SERVICE BULLETIN SUMMARY

TITLE: AIR CONDITIONING - PRESSURE CONTROL AND MONITORING - INSPECT THE SERIAL NUMBER OF THE GEARBOX OF THE OUTFLOW VALVE 10HL AND IF

NECESSARY DO A MODIFICATION TO THE GEARBOX

DATE: Oct 15/96 SERVICE BULLETIN No.: A320 - 21 - 1107

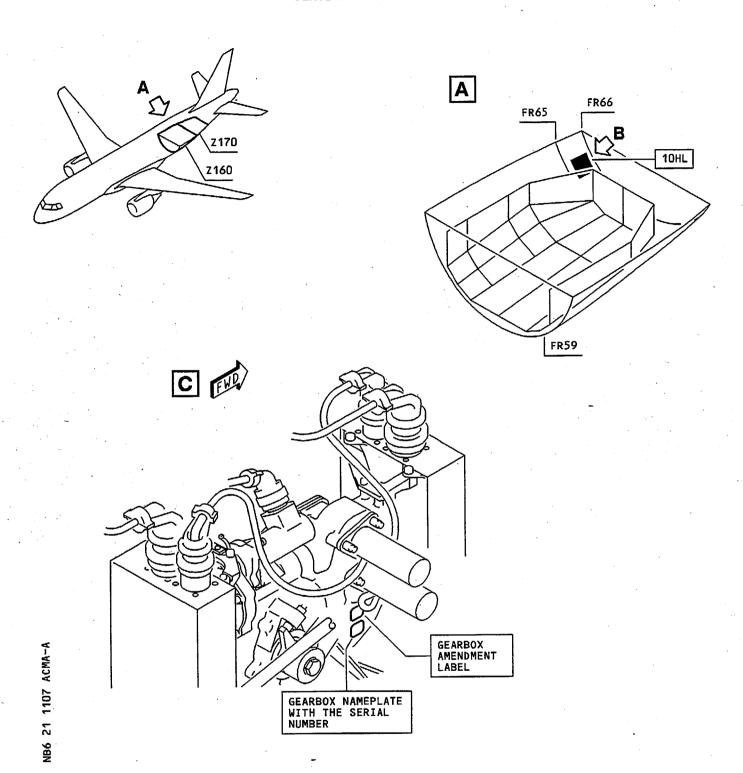
(1) Do an inspection of the gearbox serial number through the open outflow valve 10HL.

- (1) If the gearbox serial number is 9201 thru 9843 and the amendment standard D or AD has not been embodied, do the modification of the gearbox.
 - (a) Remove the outflow valve 10HL (Refer to AMM 21-31-51, P. Block 401).
 - (b) Do the modification of the gearbox in accordance with the NORD-MICRO Service Bulletin 16917-21-004.
 - (c) Install the outflow valve 10HL (Refer to AMM 21-31-51, P. Block 401).

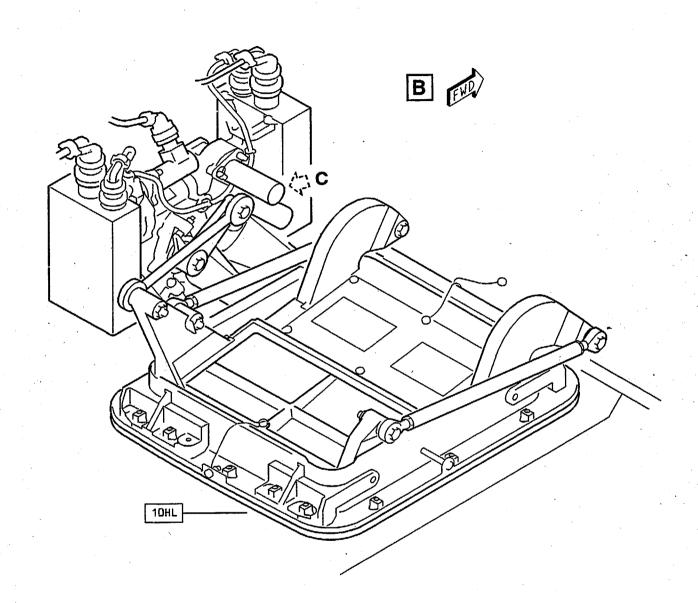
- (1) If the gearbox has been modified, do the operational test of the pressure control and monitoring system.
 - (a) Remove the safety clips and the tags and close these circuit breakers:

(b) Do the operational test of the pressure control and monitoring system (Refer to AMM 21-31-00, P. Block 501).
